The Mills Building

1700 Pennsylvania Avenue, NW Washington DC

Modification before the Board of Zoning Adjustment

District of Columbia CASE NO.19943A

Floor Plan Diagram - Ground Level

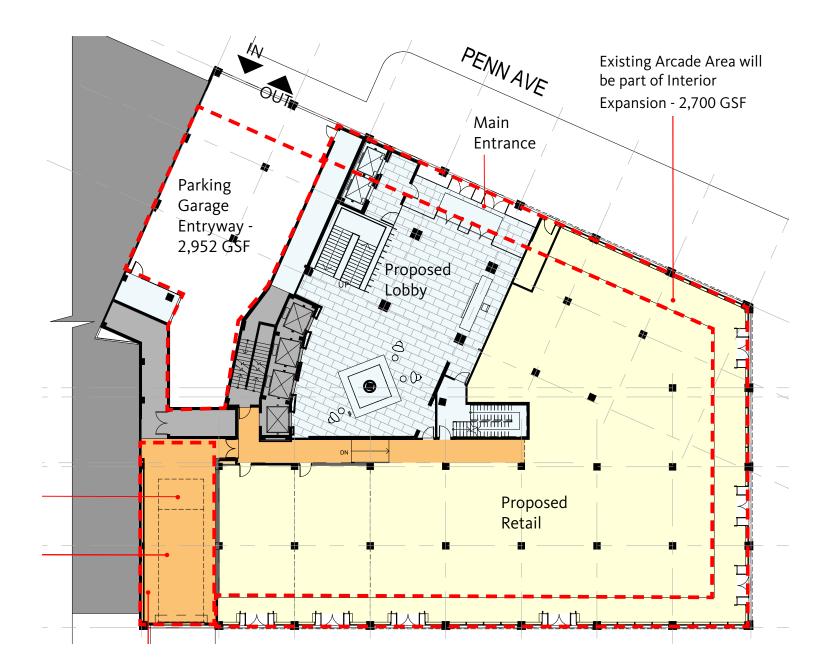
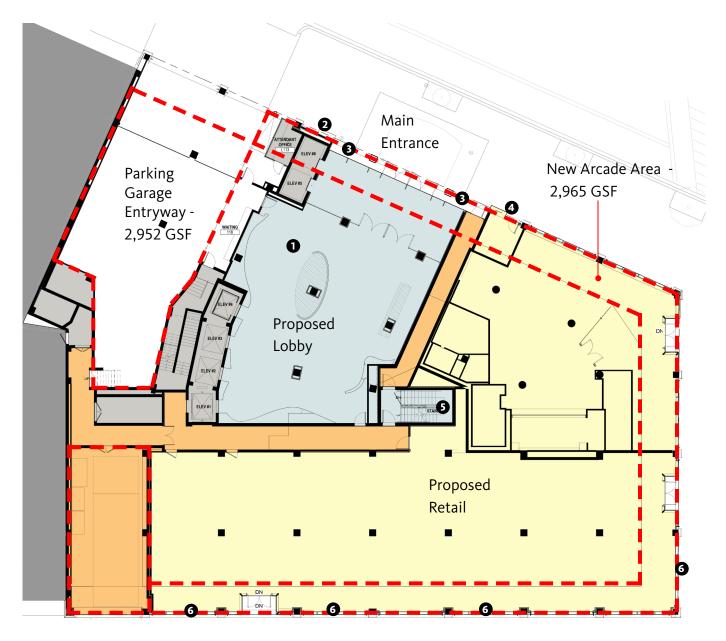
1 - Internal lobby stair removed

- 2 Elevators moved roughly 2" east to coordinate with existing footings
- 4 Fire command center revised to code-required dimensions
- 5 Egress stair shifted slightly and egress corridor added
- 6 Proposed entrance locations removed

3 - Main entrance glazing widened to include shuttle elevator lobby and egress corridor

Floor Plan Diagram - Level 2 to Level 8

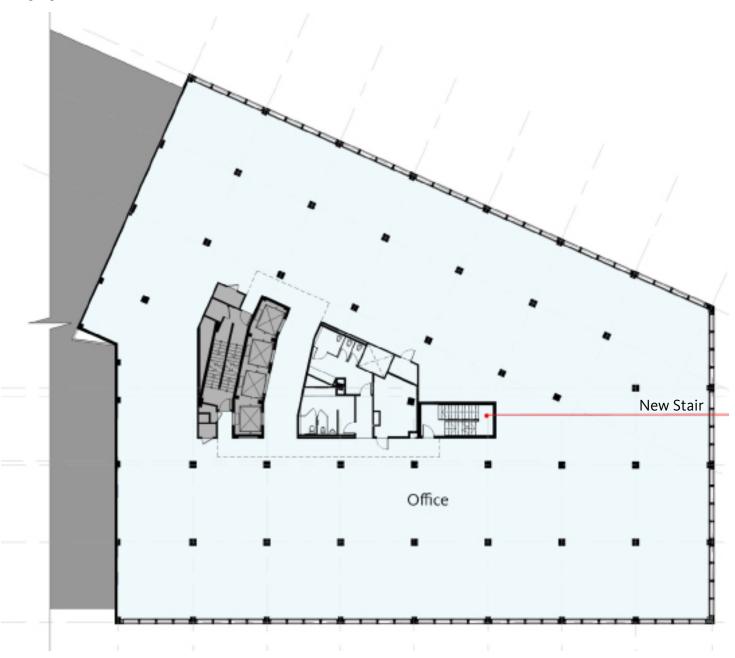
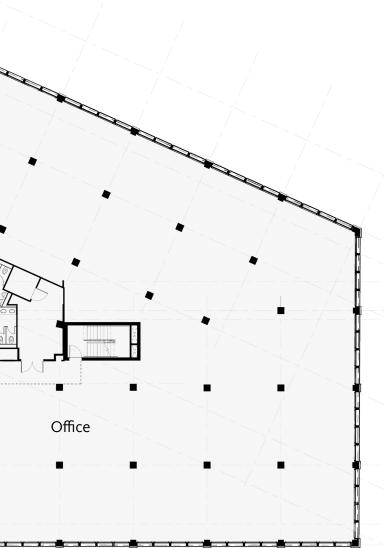
No exterior revisions compared to approved plan.

Interior revisions limited to minor changes to core layout to accomodate existing utility services to remain, new services, and ADA.

Floor Plan Diagram - Level 9

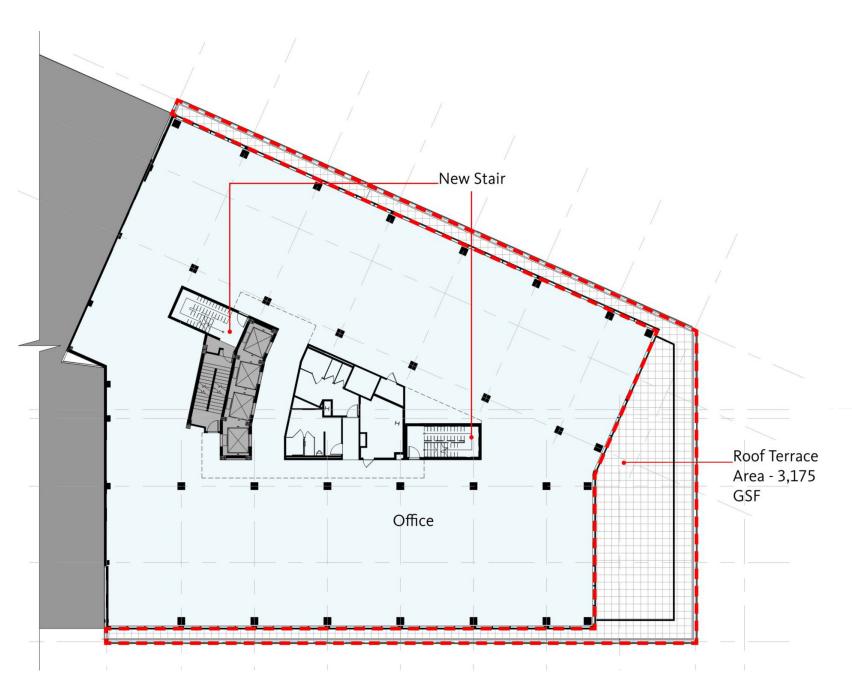
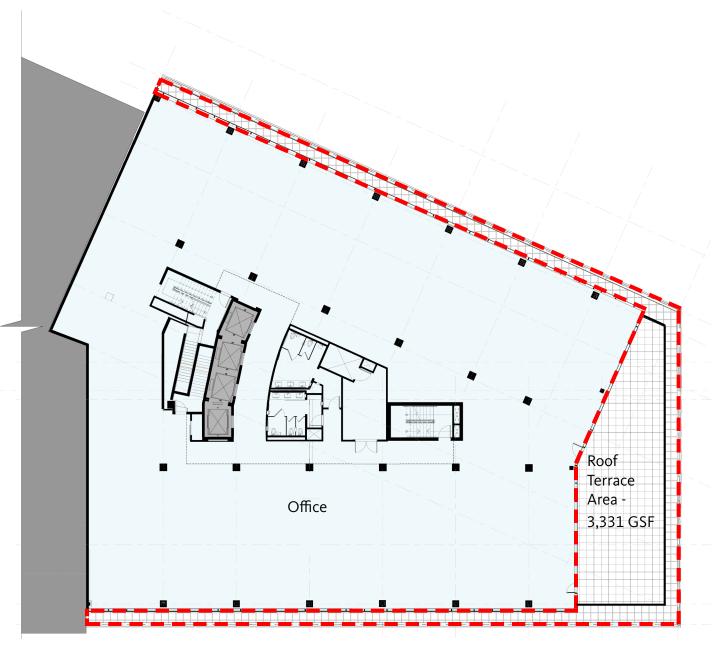
Exterior Revisions limited to facade treatments to satisfy CFA commentary which altered setbacks and terrace area slightly, and addition of doors to satisfy egress requirements from Roof Terrace. Interior revisions limited to minor changes to core layout to accomodate existing utility services to remain, new services, and ADA.

Floor Plan Diagram - Level 10 to Level 11 (16,013 GSF/ Level)

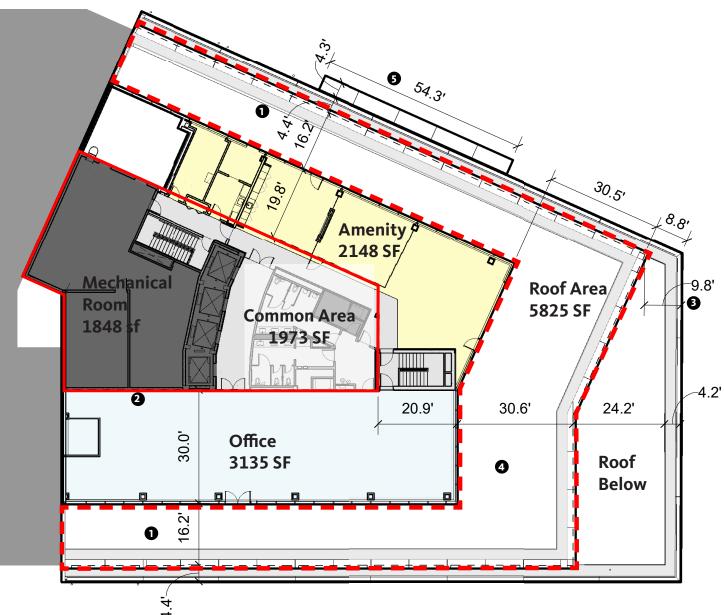
Exterior Revisions limited to facade treatments to satisfy CFA commentary.

Interior revisions limited to minor changes to core layout to accomodate existing utility services to remain, new services, and ADA.

Floor Plan Diagram - Penthouse Approved

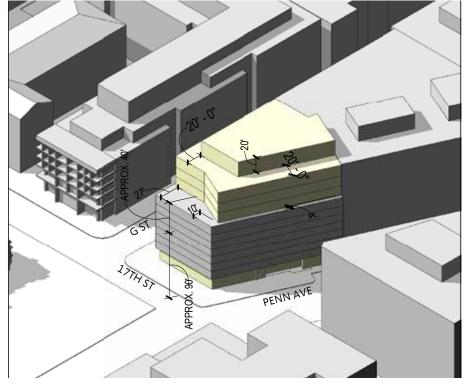
1 - Setbacks reduced slightly and penthouse enclosure stepped accordingly to meet 1:1 setback 2 - Previous design provided a height of 20' for the entire penthouse; revised design proposes a height of 15.5' for the perimeter amenity and office areas, with an additional 4.5' for the interior

mechanical and common areas.

3 - Setback of outdoor terrace reduced slightly at NE corner and increased slightly at SE corner 4 - Butterfly form introduced at east end of PH and setback dimensions increased 5- Main Entrance Canopy below at Level 2 not previously shown or dimensioned

Layout adjusted to accomodate more detailed program requirements and MEP coordination.

Massing - Originally Proposed (Top) vs. Updated (Below)

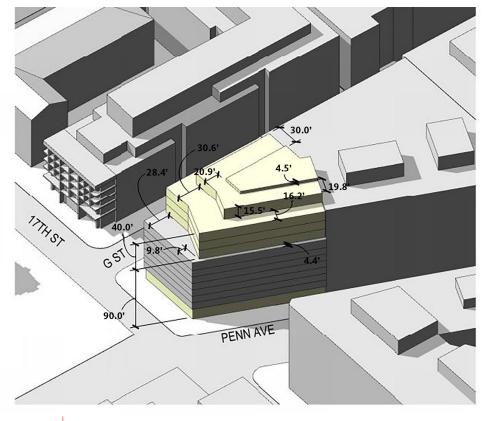
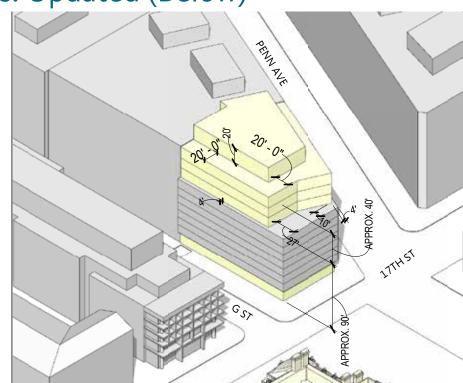
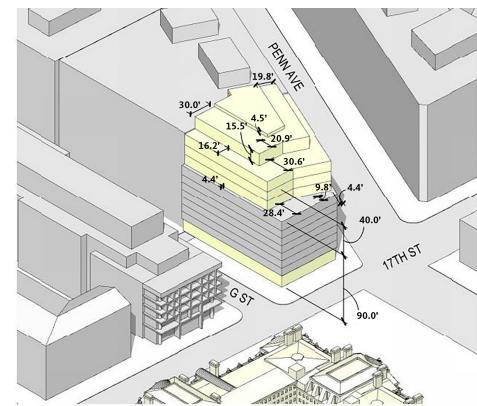
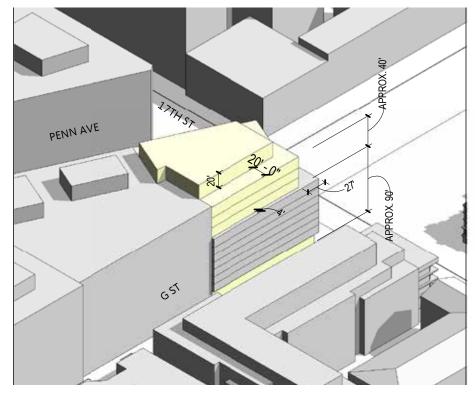
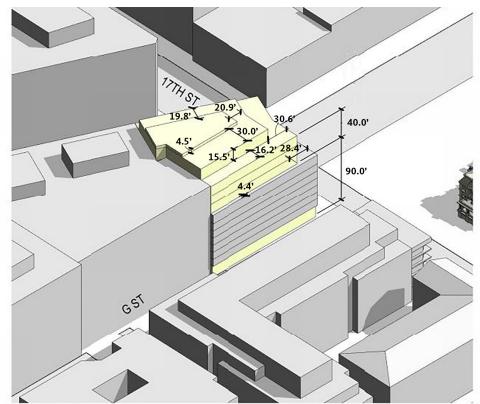
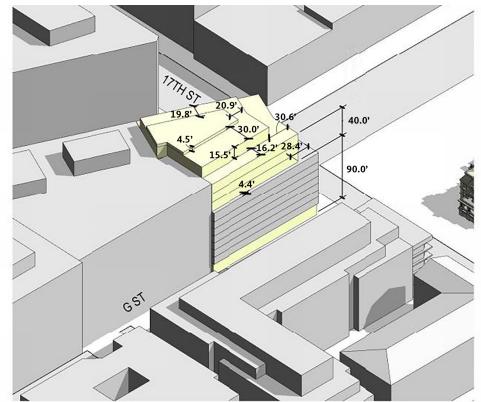
At 90.0' To 130' From Street Level:

- 4.4' Setback Along G St.
- 4.4' Setback Along Penn Ave.
- 9.8' To 28.4' Setback Along 17th St.
- No Setback Adjacent To Neighboring Property.

- At 130' To 145.5' Penthouse Roof From Street Level:
 - 20.6' Setback Along G St.
 - 20.6' Setback Along Penn Ave.
 - 40.4' to 59.0' Setback Along 17th.
 - No Setback To Adjacent Neighboring Property.

- - 50.6' Setback Along G St.

- At 145.5' To 160' Penthouse Roof From Street Level:
 - 40.4' Setback Along Penn Ave.
 - 79.9' Setback Along 17th.
 - No Setback To Adjacent Neighboring Property.
